DK98N

98Inch 4K 500nit

A0 GPO Display

DWG NO. 02

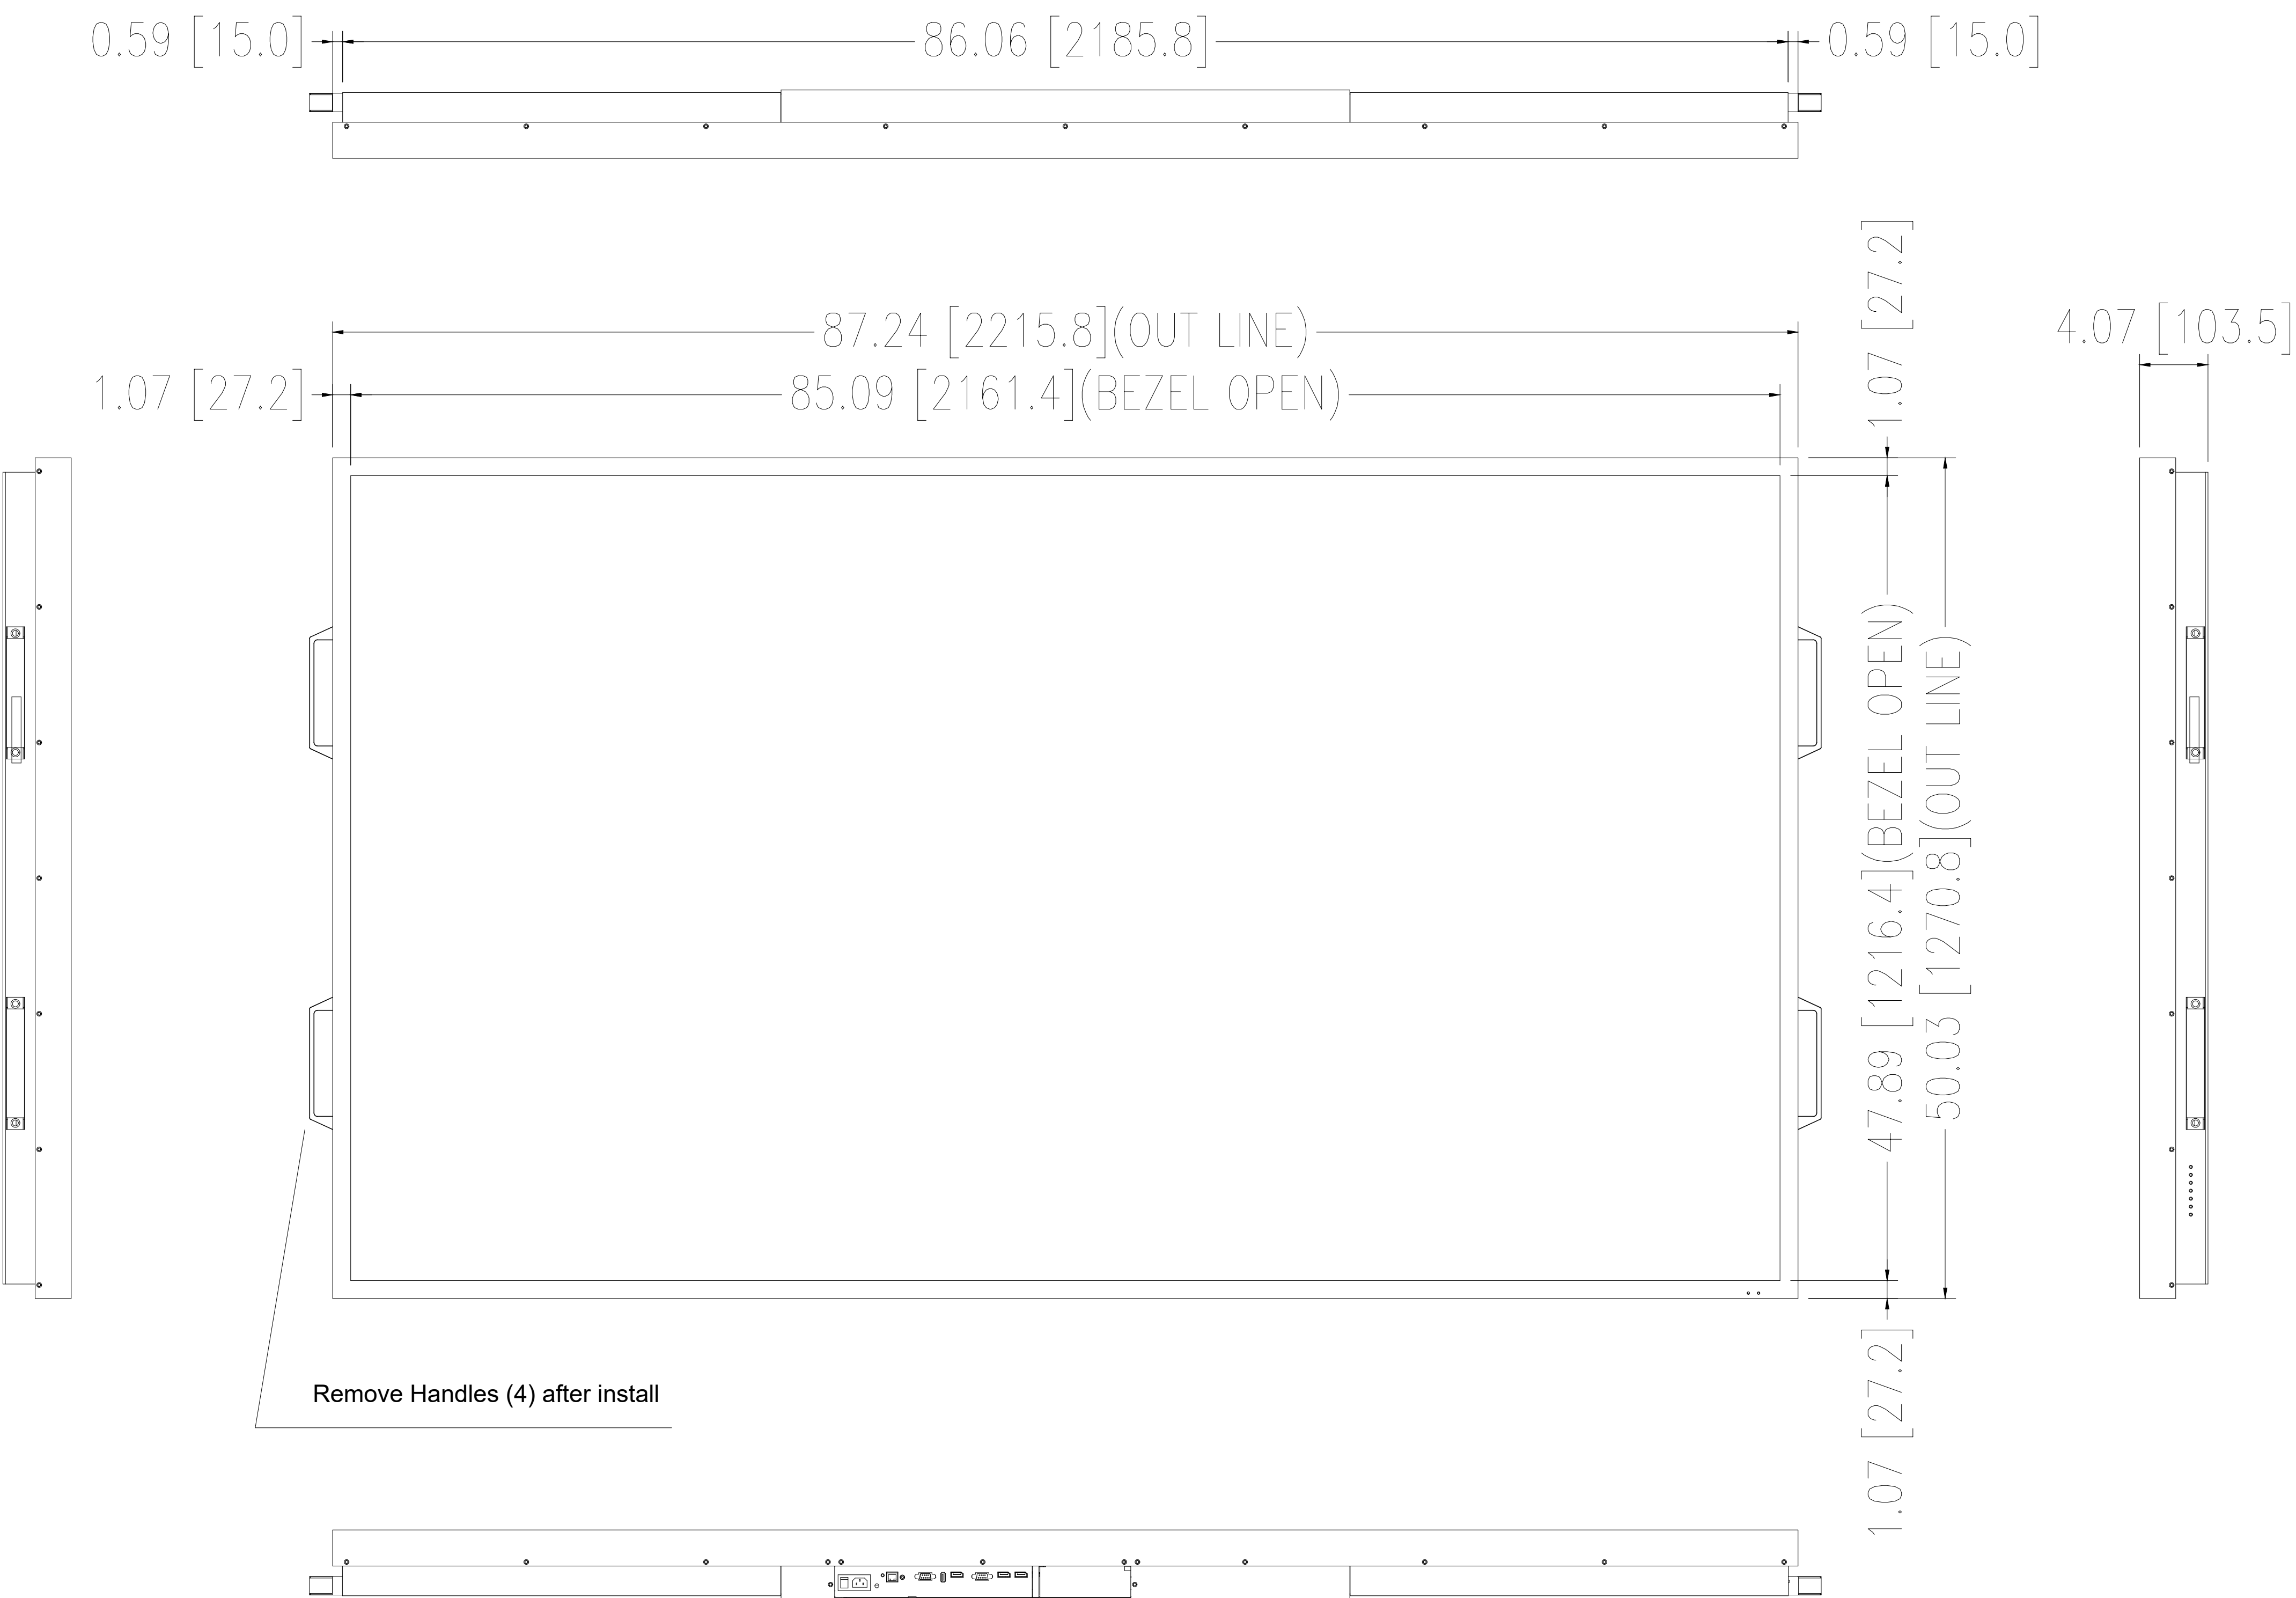
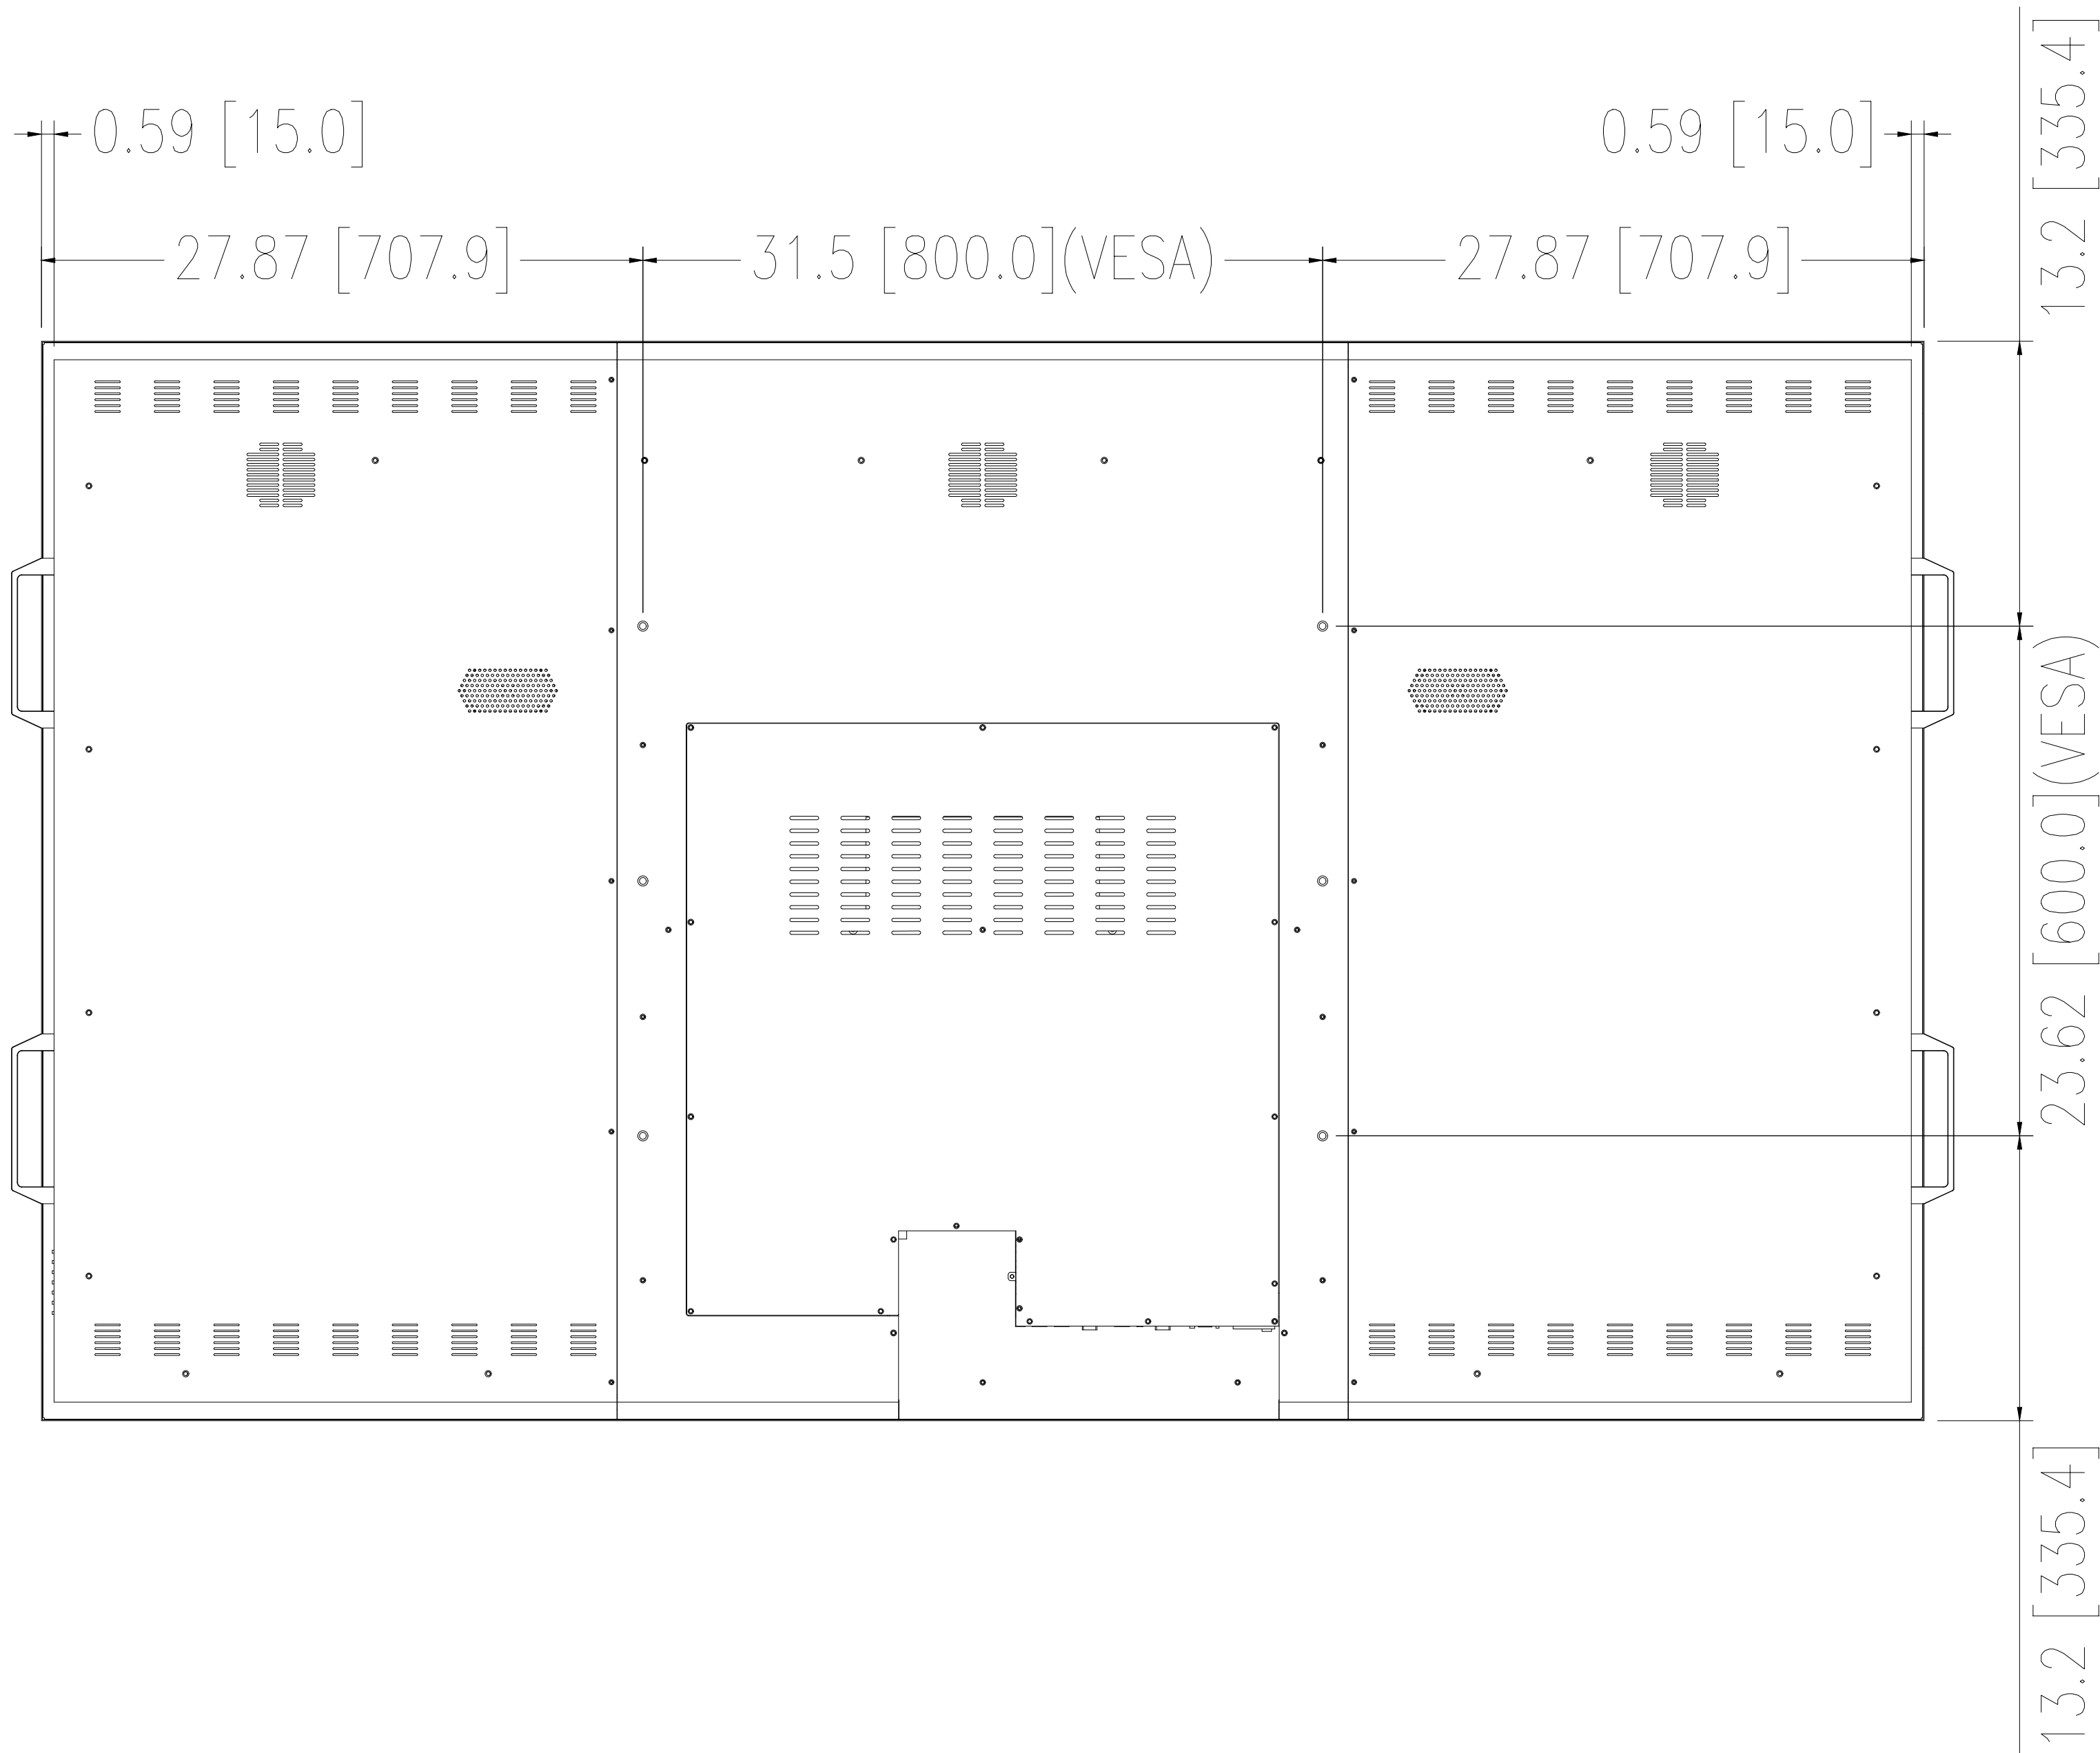
REVISIONS			
REV	DESCRIPTION	DATE	APRVD
1	Increased handle size and display depth	08.14.26	J.P.
2	Rear cover: Changed to a three-piece design for improved serviceability. Left-side front/rear bezel gap: Revised from 14.9 mm to 15.0 mm.	09.29.26	J.P.
3
